LC 66

PORTLAND GENERAL ELECTRIC
COMPANY,

2016 Integrated Resource Plan

SIERRA CLUB COMMENTS
[PUBLIC VERSION]

Figure 1: Proxy Resources by Portfolio (% of new capacity)

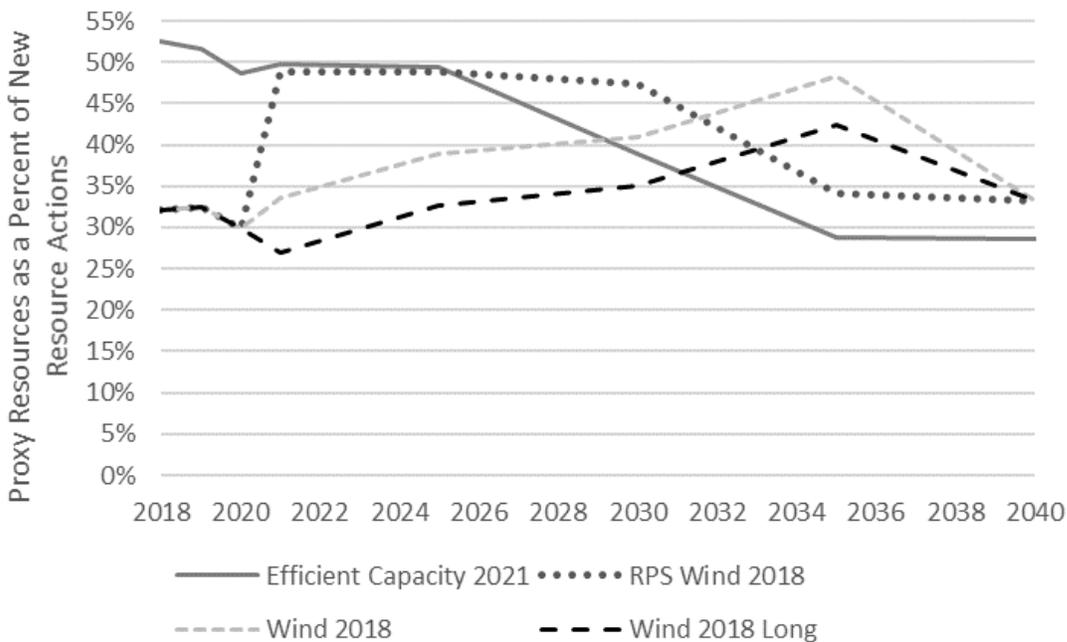
As discussed above, PGE developed portfolios of pre-determined resource mixes which generally meet energy and capacity obligations while also complying with the Oregon RPS. PGE then tested these portfolios under “futures” to determine the NPVRR under different conditions—focusing on variations of carbon, natural gas, and load forecasts. However, while the mix of specific resources changes between portfolios, the bulk of PGE’s new capacity builds is comprised of proxy resources. The prominence of proxy resources varies from portfolio to portfolio, as PGE used “generic” capacity to supply any resource need that was left over after it hand-picked specific resources to add. However, in many cases these resources come to represent a significant fraction—over a fifth—of PGE’s resource fleet, and approximately half of its near-term resource decisions, over the course of the planning horizon—shown in Figure 1.

PGE leaves the Commission with two unsatisfactory possibilities, both of which may be true to some extent. One possibility is that these resources are true “proxies” and PGE does in fact intend for *any* cost-effective mix of resources to be able to supply the associated energy and capacity. In this case, PGE is essentially asserting that, as soon as four years from the present, the composition of a sixth of its total resource mix will be a complete mystery. Will this portion

The other possibility is that PGE does, in fact, have a strong sense of what resources will fill these gaps—and that it will be an NGCC. PGE chose to model these resources as new gas-fired units, rather than contracts, hydro, or any other type of resource. PGE’s apparent capacity need is in 2021, and new NGCCs typically require four to five years to permit and construct. If PGE plans to acquire a new NGCC, it does not have time to wait until the next IRP cycle to demonstrate the cost effectiveness of this specific resource. As such, PGE has clearly stated its intent to procure a new resource as a result of this IRP, without explicitly identifying what resource it intends to procure. By deferring any explicit resource decisions until an RFP, PGE has effectively denied stakeholders the opportunity to be involved in PGE’s actual resource planning.

Figure 3: NPVRR Costs of Action Plans Relative to Preferred Portfolio (\$millions)

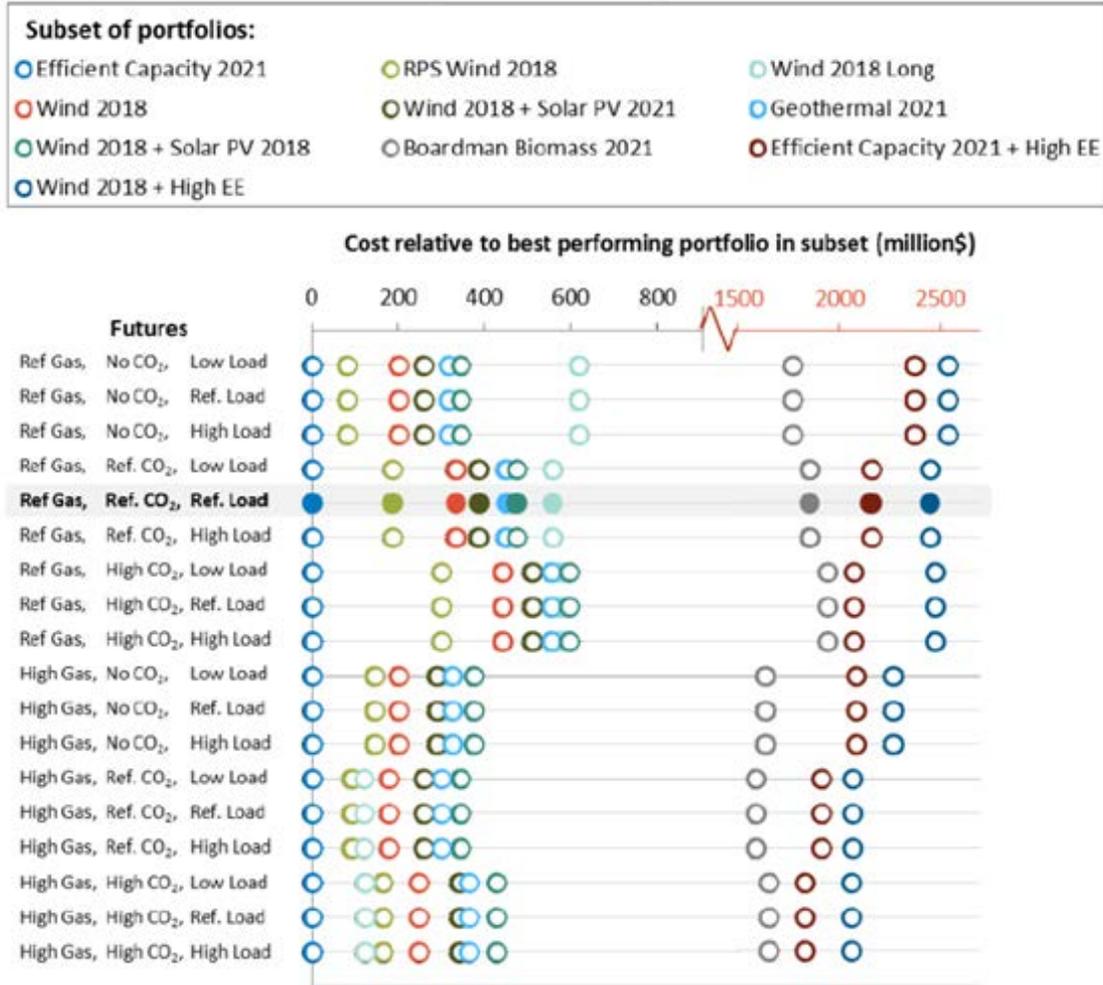
PGE's focus on minimizing its exposure to an unrealistically carbon-intensive and costly market is underscored by the results of its analysis of different load futures. PGE evaluated three different load forecasts: Reference, Low, and High. The figure below shows the results for a subset of portfolios under various futures.¹⁸ The cost reported in this figure is the difference in NPVRR between each portfolio and the preferred portfolio (Efficient Capacity 2021) under each future. Note that this difference in NPVRR does not change with load expectations. The reference, low, and high load results are the exact same, all else equal. Thus, the load sensitivity does nothing to change the ranking of portfolios amongst each other.

This result shows that the load levels do not influence the choice of portfolio. This is counterintuitive as one would expect resource procurement to change with load expectations. However, PGE did not vary the amount of capacity procured with load. The Company claimed that "the load sensitivity is intended to identify economic risks *associated with varying levels of exposure to market energy* for a given portfolio."¹⁹ The results merely tell us that if PGE procured a fixed level and mix of capacity, it would buy more (and sell less) on the market if load were higher, or buy less (and sell more) if load were lower. This is not surprising but also not informative. This result emphasizes the impact of PGE's market assumptions on its portfolio results, the scoring thereof, and—ultimately—its selection of a preferred portfolio.

Recommendation: PGE should evaluate specific resource options throughout the entire analysis period, including gathering sufficient data and allowing capacity builds to change with load expectations.

Figure 4: Historical EE Savings vs. Projected EE Savings in PGE 2016 IRP (% of annual sales)

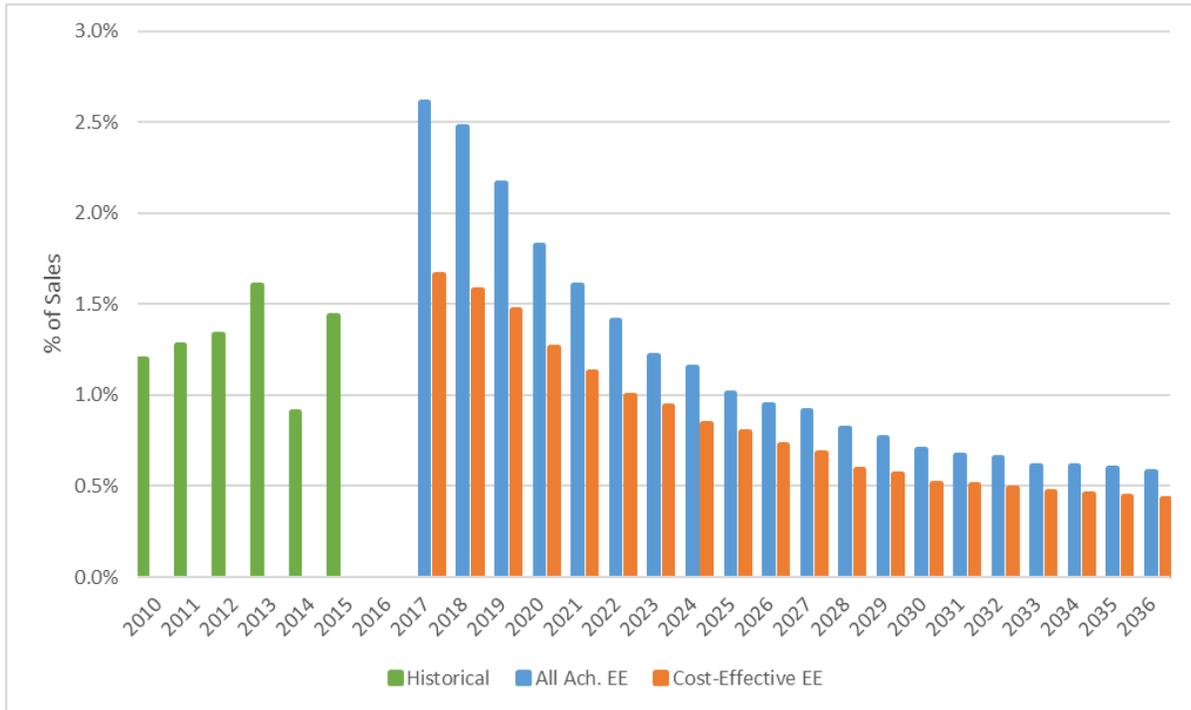
Energy efficiency programs under PGE's service territory are handled by the ETO, Oregon's statewide third-party EE program administrator. ETO has recently achieved about 1.5 percent annual savings, as shown in Figure 4 below.⁴⁵

However, PGE’s IRP (which adopted ETO’s recent analysis) predicts that future energy savings will substantially decline over time. Shown as "cost-effective EE" above, PGE expects a similar level of savings in 2017 at about 1.7 percent but this declines to less than 0.5 percent by 2033. The all achievable potential ("All Ach. EE" above) includes the level of EE that is technically possible yet not all of this is cost-effective. These declining savings projections are not supported by any historical evidence in the region. For example, utilities in the Northwest together have increased energy savings year by year since 1978 (shown below).⁴⁶

Figure 5: Historical Energy Savings Achievements in the Northwest Region (aMW)

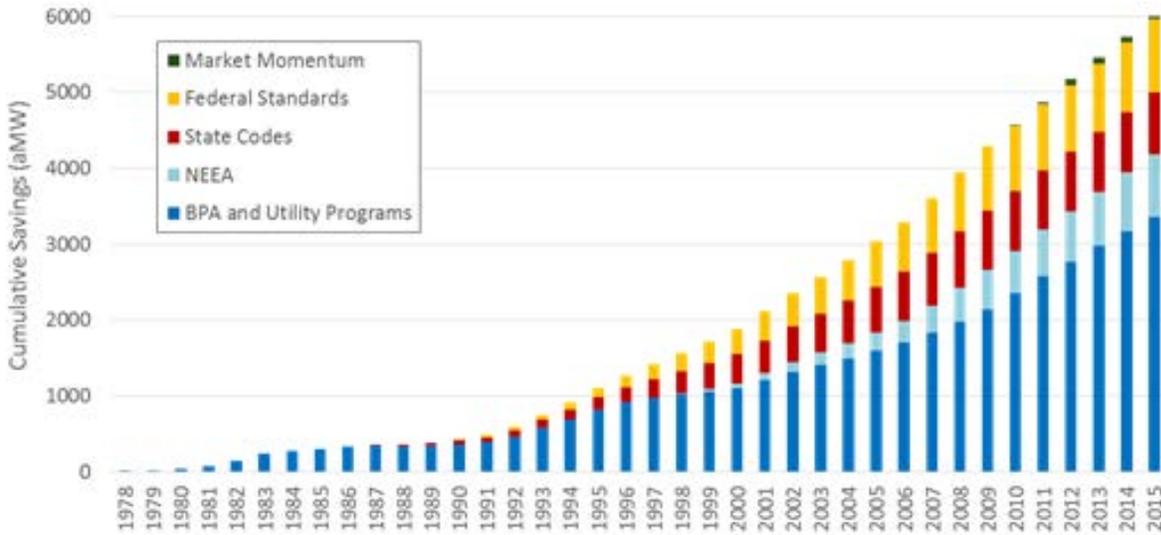
The Pacific Northwest shows no sign of shedding EE savings in the future. Despite the region’s impressive efforts to tap into the region’s EE potential already, the latest NWPCC power plan in 2016 has found an additional 4,300 average MW (aMW) potential over the next 20 years.⁴⁷ Additional EE has the potential to avoid or at least delay construction of new generating facilities. Unfortunately, the rigid and inflexible structure of PGE's analysis does not allow for this possibility and, if it did, the effect would be muted by the faulty assumption that EE savings will rapidly diminish.

Figure 6: Projected Costs of Saved Energy (cents per kWh) vs. Savings (% of annual sales)

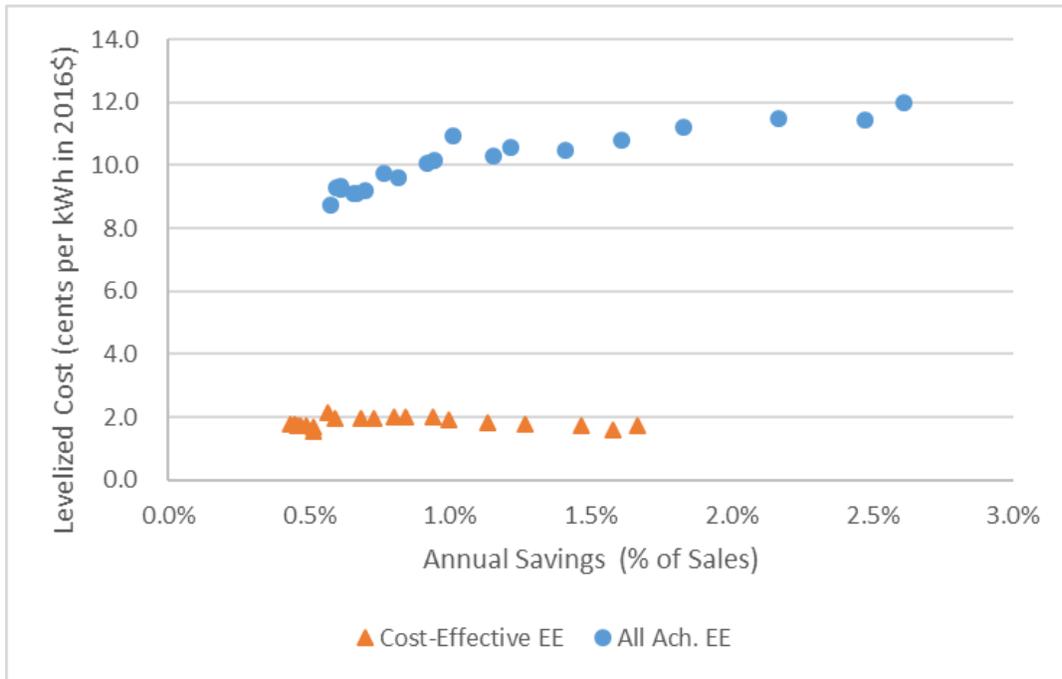
Based on the program costs and savings data provided at Table 6-1 of the IRP, we estimate that the levelized total resource cost of the efficiency programs over the lifetime of the measures is about 2 cents per kWh for cost-effective EE, and 9 to 12 cents per kWh for the all achievable EE.⁴⁸ These levelized costs are shown in Figure 6 below where we compared the cost of saved energy with the annual projected savings estimate as a percentage of sales.

PGE is clear that these costs are “total resource costs,” which include both program costs and out-of-pocket participant costs. However, the cost estimate for all achievable EE is likely too high. This projects 2 to 2.5 percent savings per year in the first few years and diminishing annual savings over time to about 0.5 percent (as shown in Figure 4). Historical evidence suggests that aggressive programs at similar savings levels will not increase program costs per kWh savings and can maintain these high levels of savings over multiple years. For example, Massachusetts and Rhode Island have achieved 2 to 3 percent annual savings in recent years, yet their program costs have been very stable at around 3 to 4 cents per kWh.⁴⁹ The total resource costs—which include participant spending—for these two states are about 4 to 6 cents per kWh.⁵⁰ This implies that the cost estimates for the all achievable EE are likely overstated.
